Substantive response of the Local Highway Authority to a planning consultation received under The Development Management Order.

Planning Application Number: 24/00854/REM

Application Address: Land East of The Windmill Inn Brascote Lane Newbold Verdon Leicestershire

Description of Application: Re-consultation. Application for Reserved Matters (site layout, scale, appearance, and landscaping) of outline planning application 22/00277/OUT for 239 dwellings with associated internal road layout, car parking, drainage, and landscaping.

Details of the internal layout of the site are provided on Travis Baker drawing number 015 Rev. D. The Applicant has indicated that they wish for the main internal development road to be put forward for adoption.

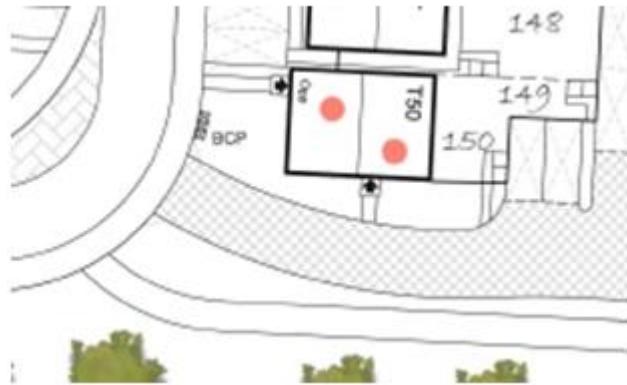
- It is noted some of the proposed side roads have a proposed width of 5.5m, which is inappropriate for their use, the Applicant should amend these to detail a width of 4.8m.
- Whilst the LHA required the access road into the development to have a width of 6.75m it is inappropriate for this road width to be extended into the site for the distance it is currently proposed. The Applicant should amend the road width to detail the width reducing to 5.5m from the end of the raised table at plots 205 and 43.

The carriageway width should comply with the design requirements as detailed in Part 3, Table DG1 of the LHDG for a road serving 50 to 400 dwellings.

- The Applicant should amend the layout plan to design speed control into the layout to maintain a 20mph design speed. Further information on speed control can be found in Part 3 of the LHDG.
- The Applicant should clearly identify access roads, access ways and any shared surfaces to be installed on site.
- The Applicant is required to remove the junction stub fronting plots 222-221 and extend the private drive to mirror the one serving plots 150 to 153 shown below.

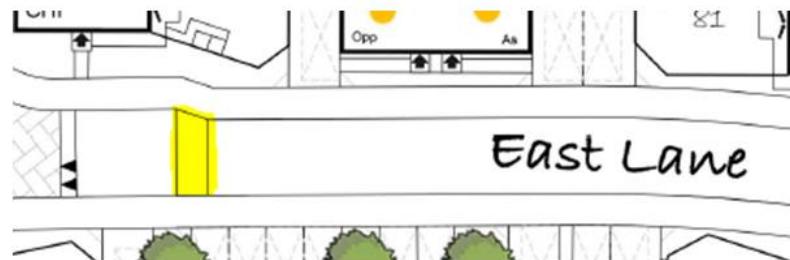
- The design plan details that the roads shown below fail to serve the required number of direct frontage access points (minimum six or more) as detailed in Part 3 of the LHDG. It should be noted even if the road provides access to private drives this does not count as direct frontage access.
